City of Portland, Maine - Building or Use Permit Application
 389 Congress Street, 04101 Tel: (207) 874-8703, Fax: (207) 874-8716

PERMIT ISSUED	
Permit No: 01-1371	Issue Date: 1 9 2001
CBL: 284 F015001

Location of Construction: 93 Kent St	Owner Name: Lieberman Susan E	Owner Address: 95 Kent St	Phone: 207-73-4691
Business Name: n/a	Contractor Name: Yankee Restoration & Building	Contractor Address: 73 Warren Ave Westbrook	Phone: 2078548400
Lessee/Buyer's Name n/a	Phone: n/a	Permit Type: Additions - Dwellings	Zone: R-3

CHECK-LIST AGAINST ZONING ORDINANCE

Job: F52932 Truss: A Truss Type: FLOOR Qty: 34 Ply: 1 (optional)
 SPROWL BUILDING COMPONENTS, SEARSMONT, ME. 04873, E. B. 4201 SR1 © Nov 18 2000 MITek Industries, Inc. Thu Sep 08 13:39:14 2001 Page 1

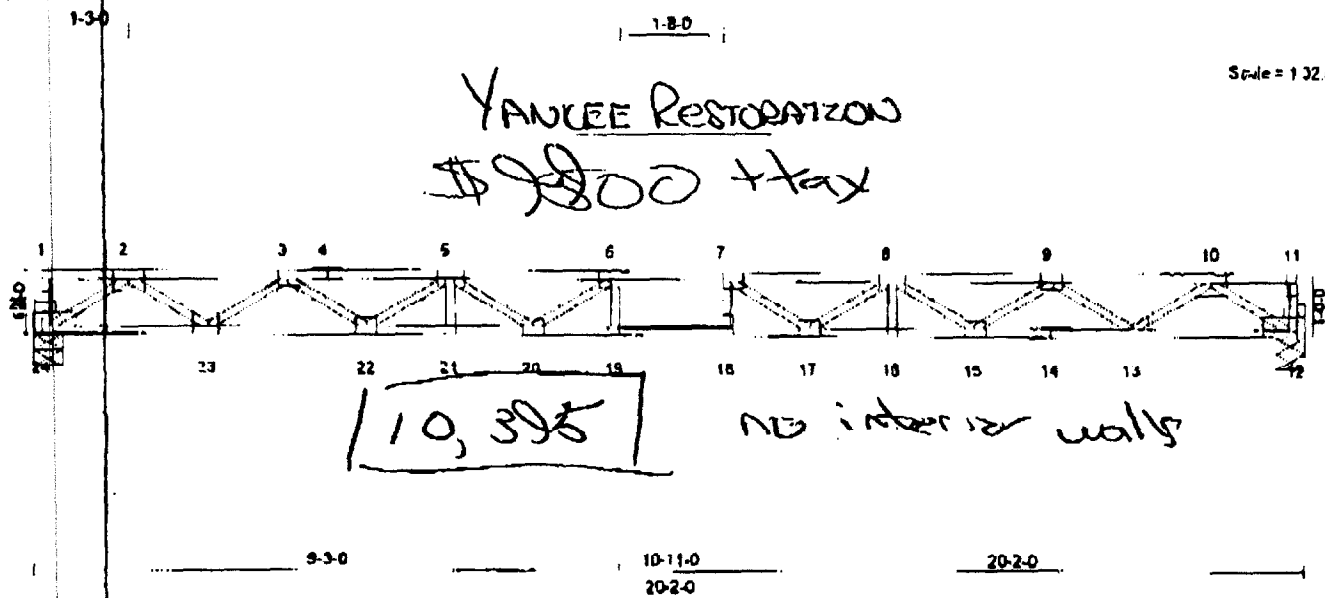
DATE	TIME	CONTACT	NARRATIVE	INITIALS
ok			① Floor Truss Specs radiant under floor	
ok			② 2 nd Floor Bath safety glazing	
ok			③ 1 Truss per sleeping area	
ok			④ 2 nd Floor Right BP cantilever framing detail	
ok			⑤ Stair Geometry Specs	TK 6'8"
			⑥ Porch Floor Framing Detail	S & H
			⑦ Guardrail & Handrail Dimensional Detail	
			Reviewed Plans @ BOCC	
11/14			Met w/ Michael Chrook	
			Called Yankee Restoration & Lieberman left message for call back. Designer advised that not all drawing sheets current	
11/14			Reviewed with Steve Tracey & Will Cheever. Information to be fixed over.

1) I am faxing you Sprowl Building components
for floor truss design.

Job	Truss	Truss Type	Qty	Ply
R62941	B	COMMON	11	1

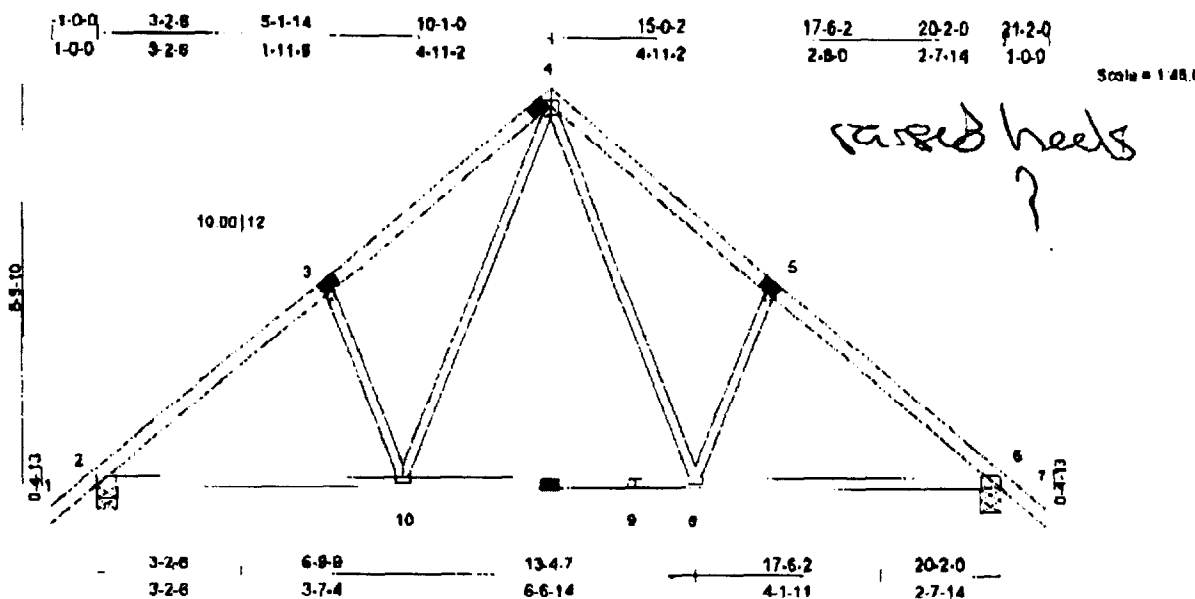
raised heels ?
